**City of Ketchum  
Planning & Building**

IN RE: )  
)  
The Perry Building ) KETCHUM PLANNING AND ZONING COMMISSION  
Condominium Subdivision Preliminary Plat ) FINDINGS OF FACT, CONCLUSIONS OF LAW, AND  
File Number: P22-045B ) DECISION  
)  
Date: March 28, 2023 )  
)

**PROJECT:** The Perry Building

**APPLICATION TYPE:** Condominium Subdivision – Preliminary Plat

SHEET 1 OF 6  
 Job No. 8059-02

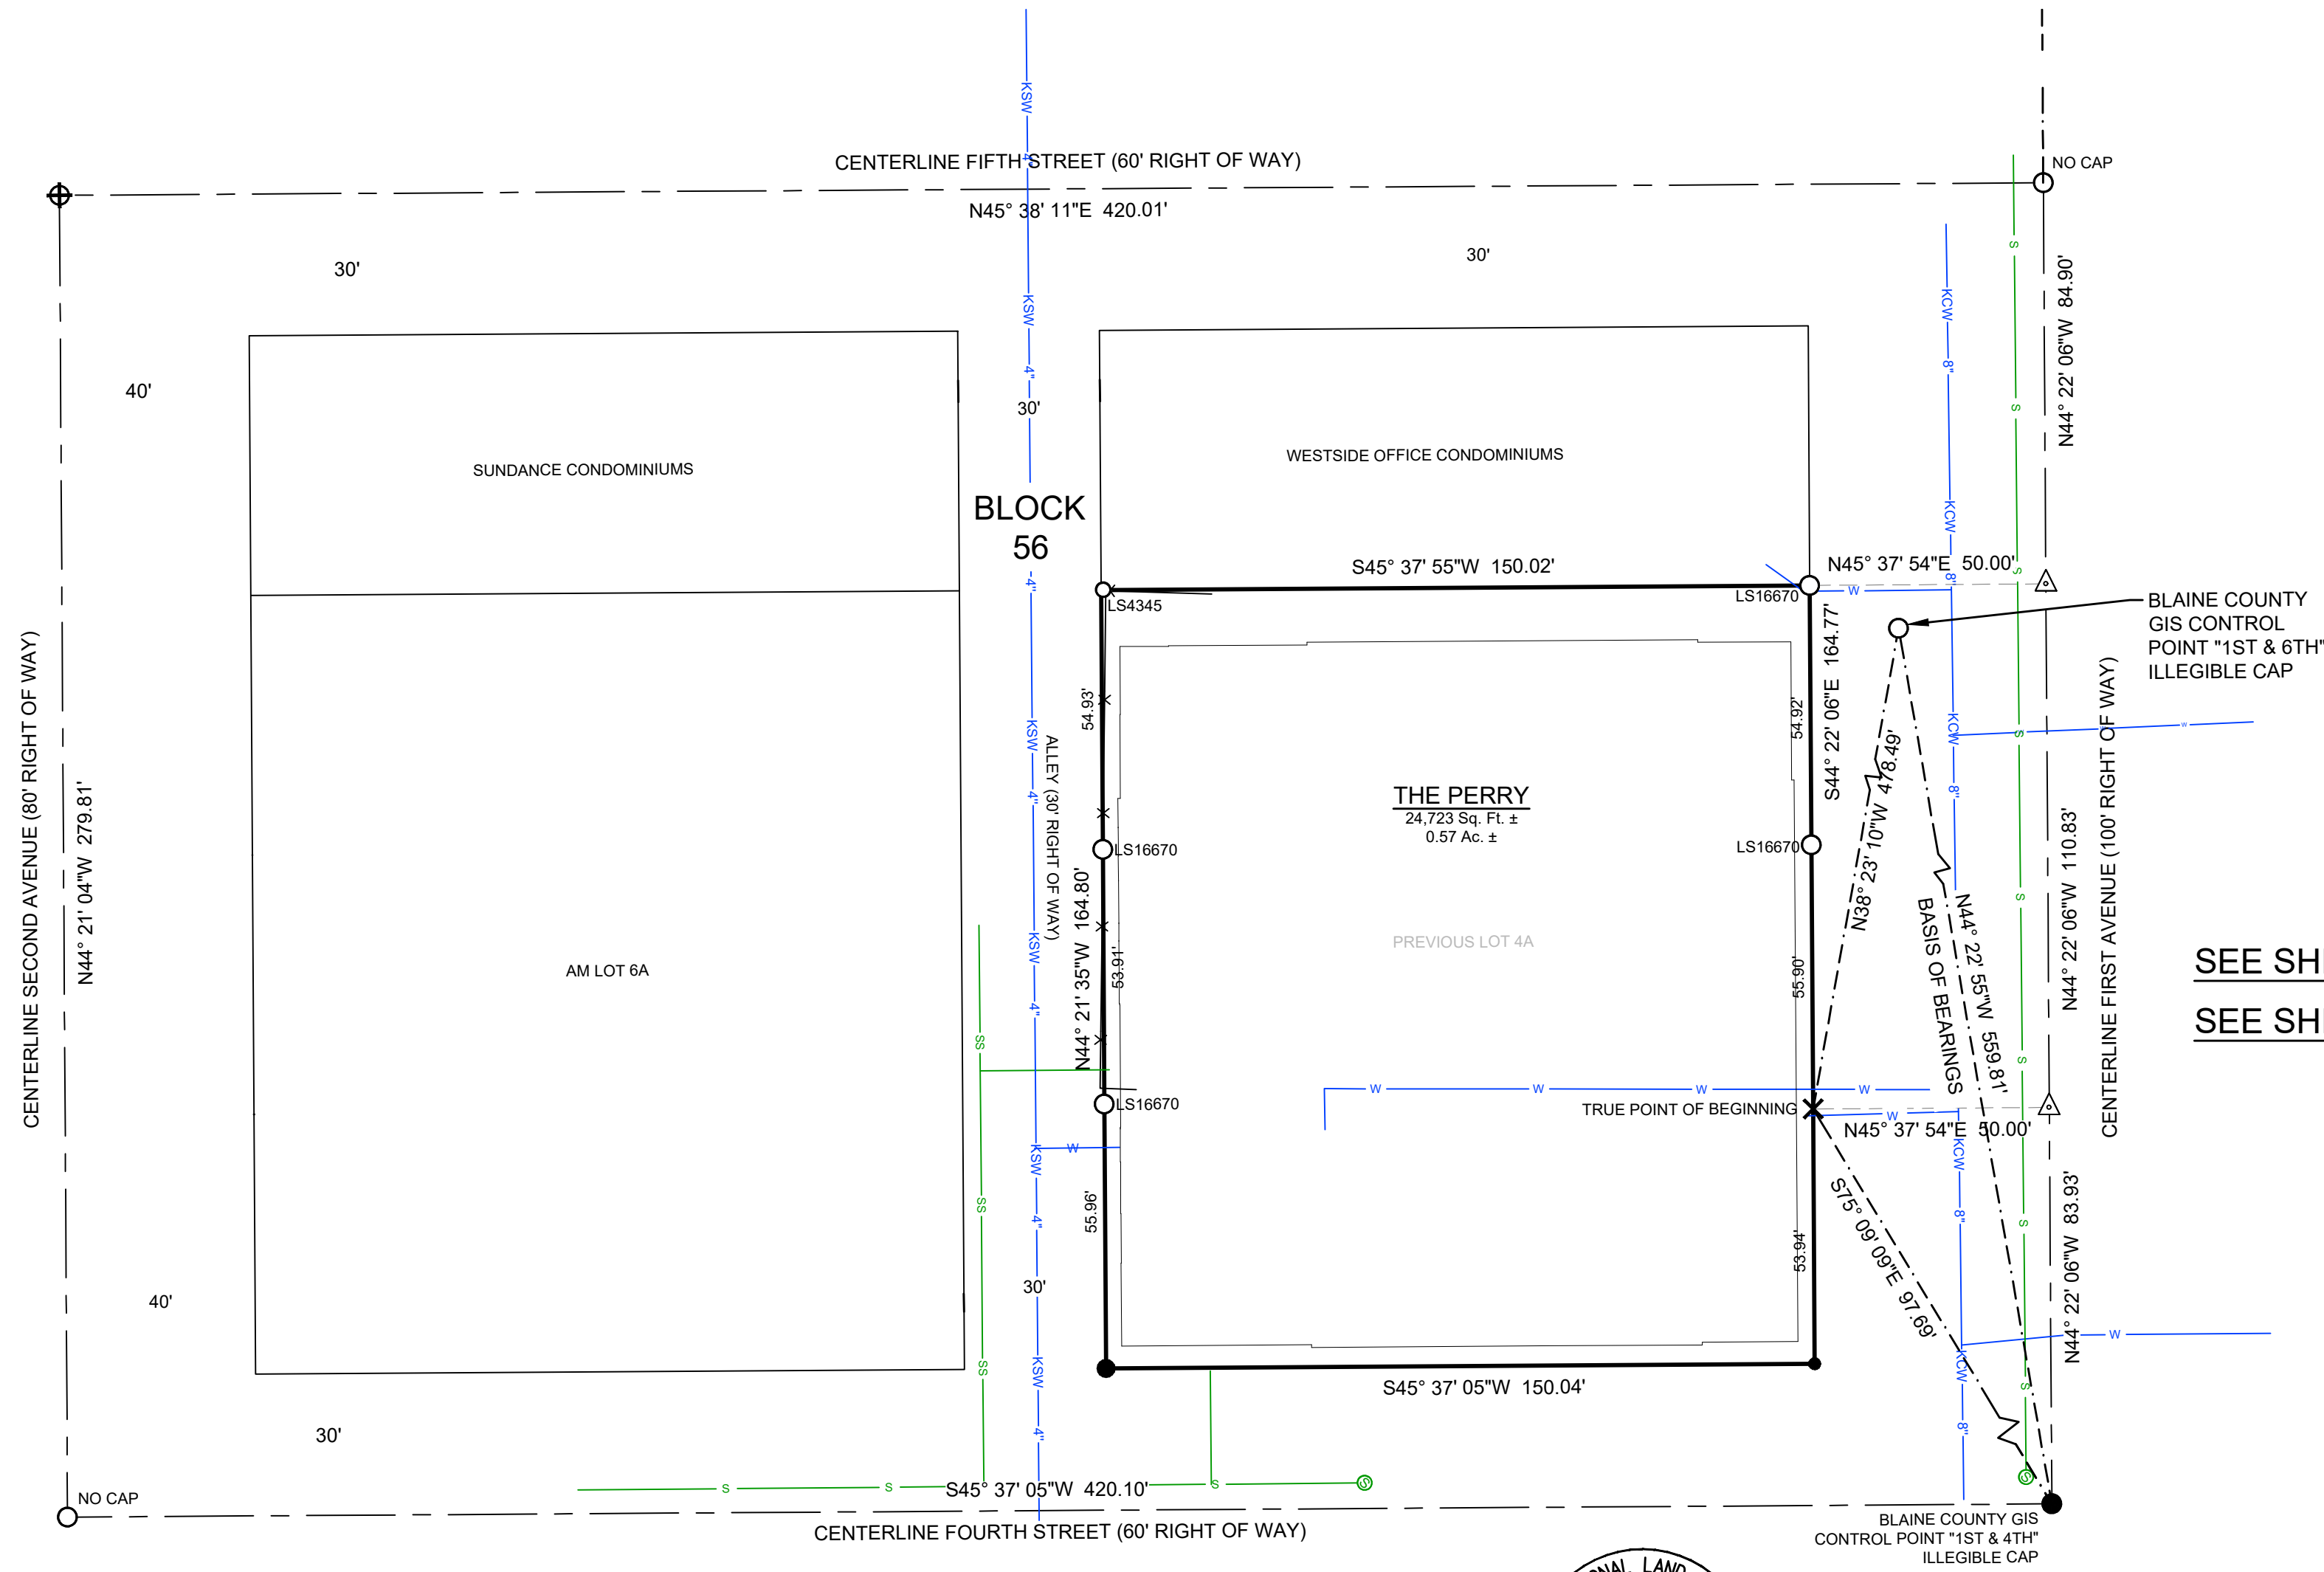
<b>The scale, north point and date.</b>
			<i>Findings</i>	<i>This standard is met as shown on Sheet 1 of the preliminary plat.</i>
<input checked="" type="checkbox"/>	<input type="checkbox"/>	<input type="checkbox"/>	<b>16.04.030.J.2</b>	<b>The name of the proposed subdivision, which shall not be the same or confused with the name of any other subdivision in Blaine County, Idaho.</b>
			<i>Findings</i>	<i>As shown on Sheet 1 of the preliminary plat, the plat is titled "The Perry" which is not the same as any other subdivision in Blaine County, Idaho.</i>
<input checked="" type="checkbox"/>	<input type="checkbox"/>	<input type="checkbox"/>	<b>16.04.030.J.3</b>	<b>The name and address of the owner of record, the subdivider, and the engineer, surveyor, or other person preparing the plat.</b>
			<i>Findings</i>	<i>The name of the owner and surveyor is shown on Sheet 1 of the plat. The plat was prepared by Mark E. Phillips of Galena Engineering.</i>

<input checked="" type="checkbox"/>	<input type="checkbox"/>	<input type="checkbox"/>	<b>16.04.030.J.8</b>	<b>Boundary description and the area of the tract.</b>
			<i>Findings</i>	<i>Sheet 1 provides the boundary description of the area. The total area of Lot 2A is 24,723 as noted on the preliminary plat map.</i>
			<b>16.04.030.J.9</b>	<b>Existing zoning of the tract.</b>

SHEET 3 OF 6  
Job No. 8059-02

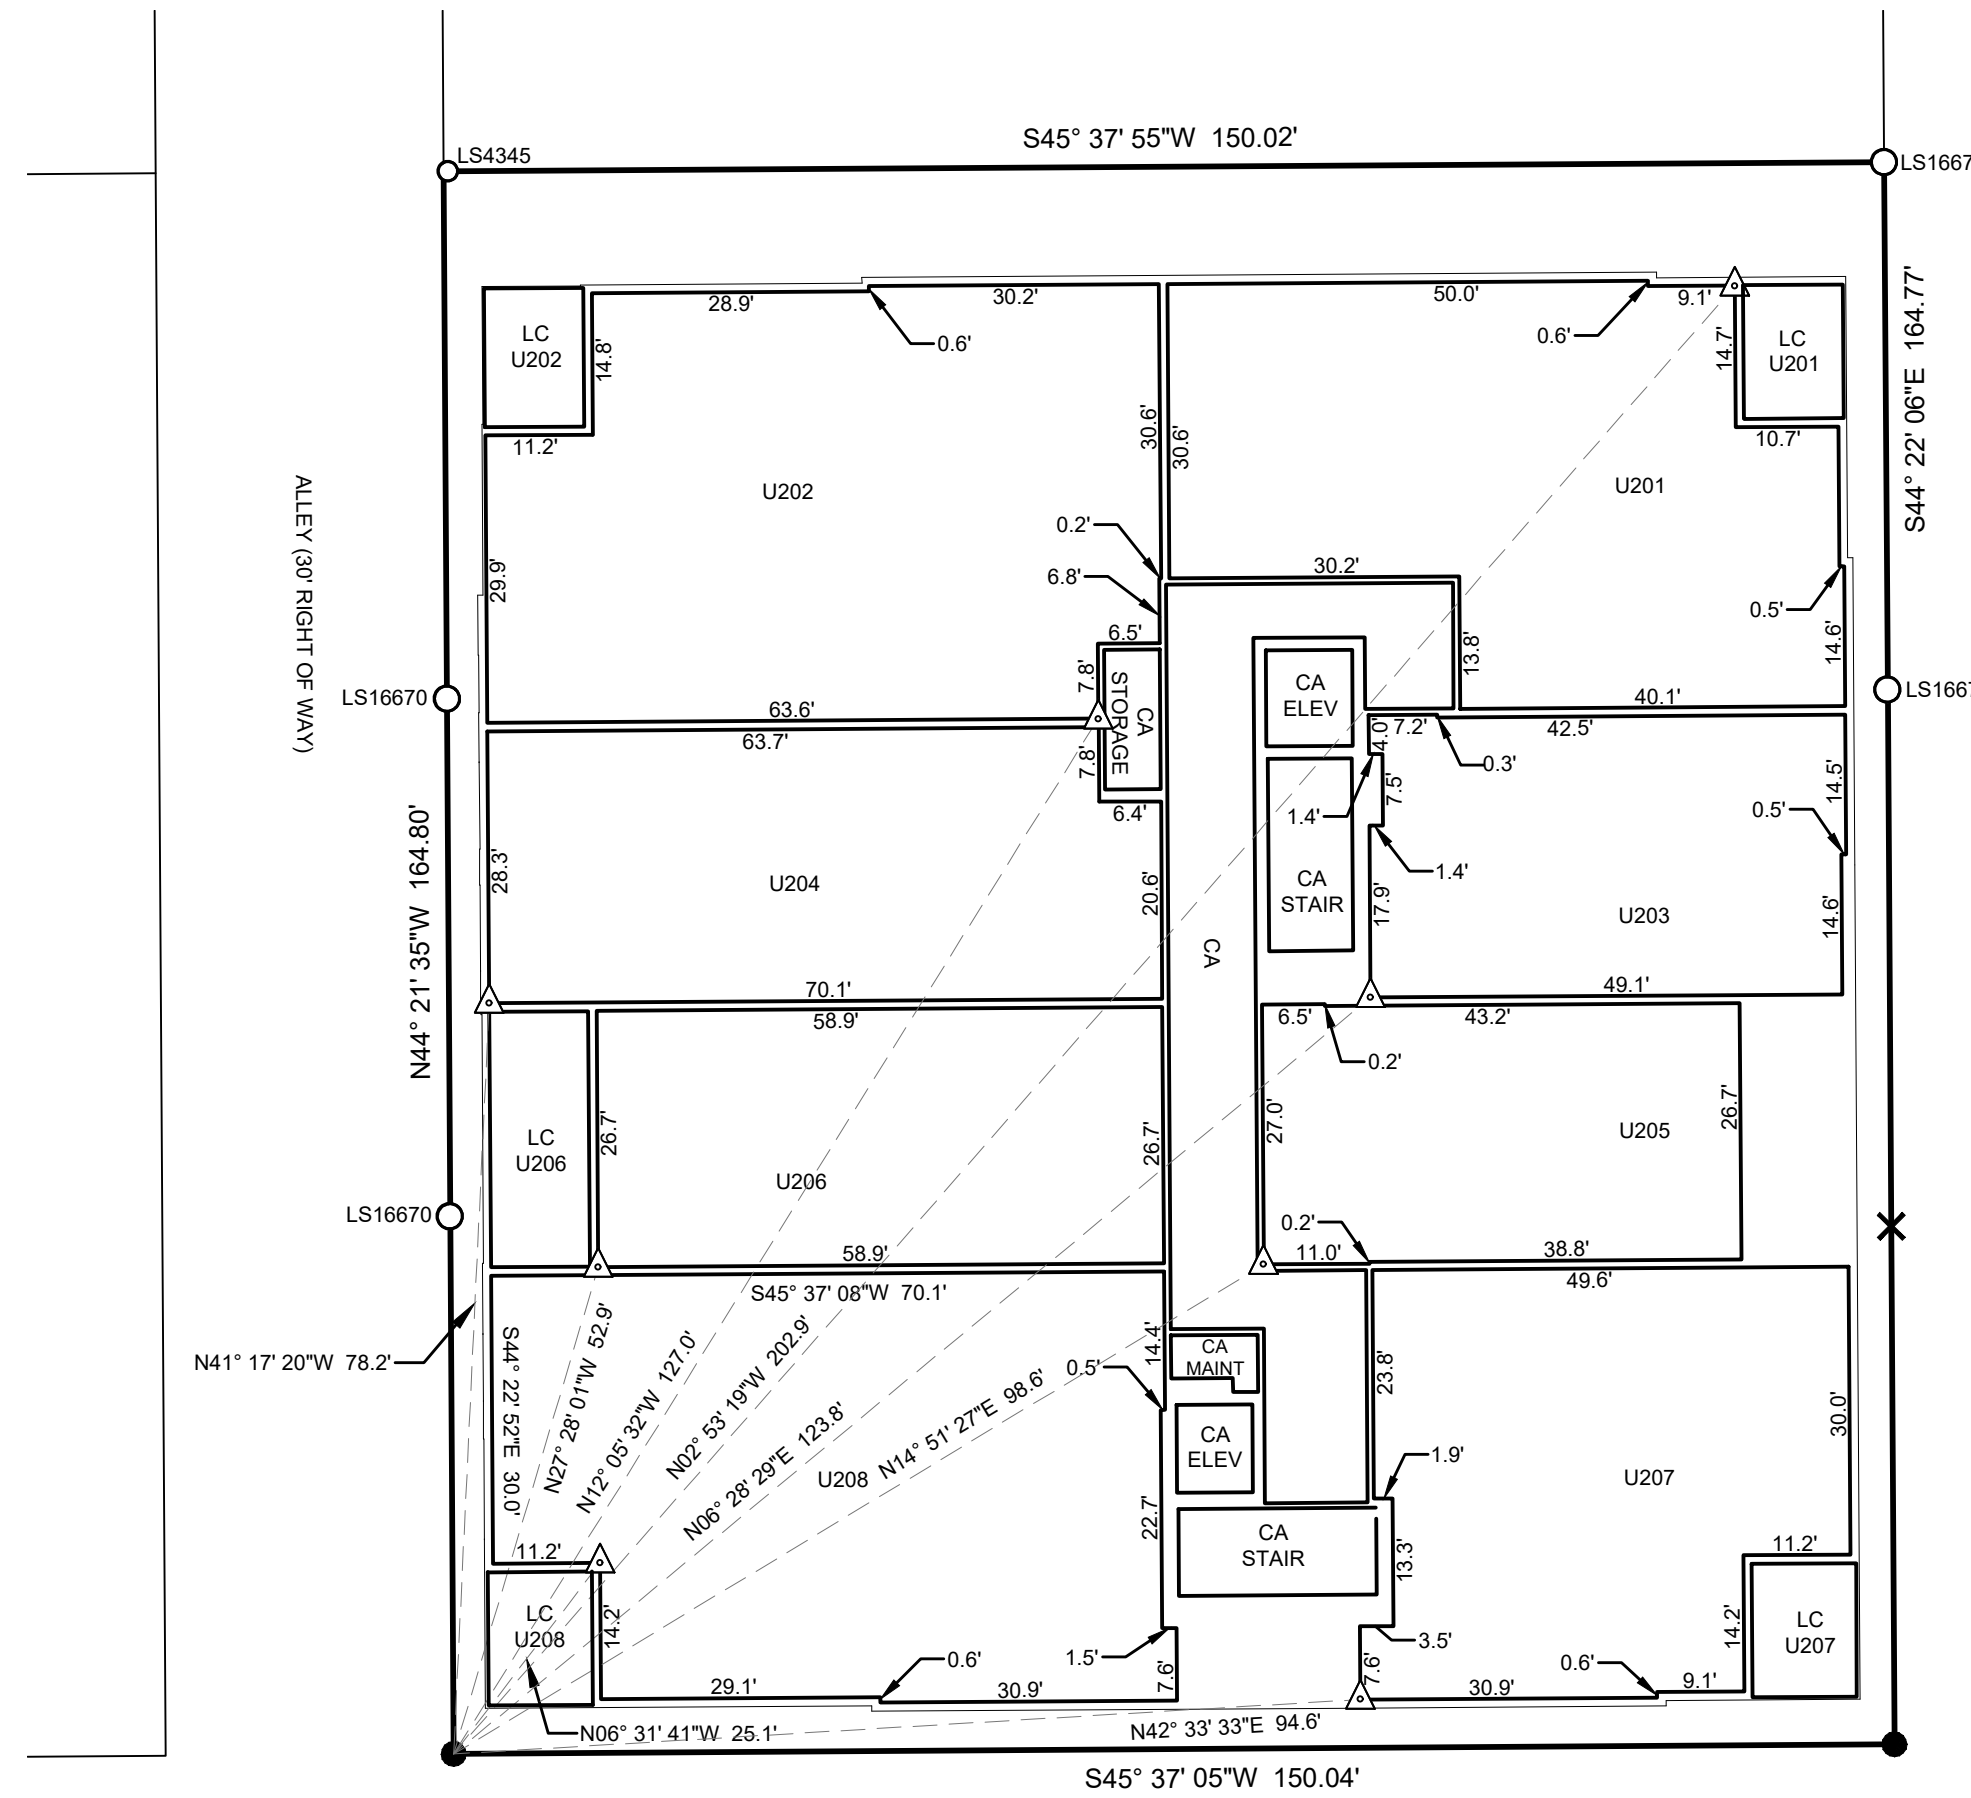
<i>Findings</i>	<i>As shown on Sheet 5 of the preliminary plat, the open parking area within the garage is designated as common area and the private garages are designated as limited common elements and specifically referenced to a unit number.</i>
<input checked="" type="checkbox"/>	<input type="checkbox"/>	<input type="checkbox"/>	<b>16.04.070.E</b>	Adequate storage areas shall be provided for boats, campers and trailers, as well as adequate interior storage space for personal property of the resident of each condominium unit.
			<i>Findings</i>	The applicant addressed storage in their response to the completeness review comments stating: <i>Adequate storage is provided as follows:</i> <ul style="list-style-type: none"> <li>• <i>Interior Storage Space within residential units: Residential units were thoughtfully designed with an abundance of internal storage space options per the floor plans.</i> <ul style="list-style-type: none"> <li>○ <i>L1 Units: Interior closet @ entry to each unit for storage. Large closet in primary bedrooms. Patio areas provide additional storage options for bicycles and other recreational equipment.</i></li> <li>○ <i>L2 Units: Large closets throughout all units.</i></li> </ul> </li> </ul>
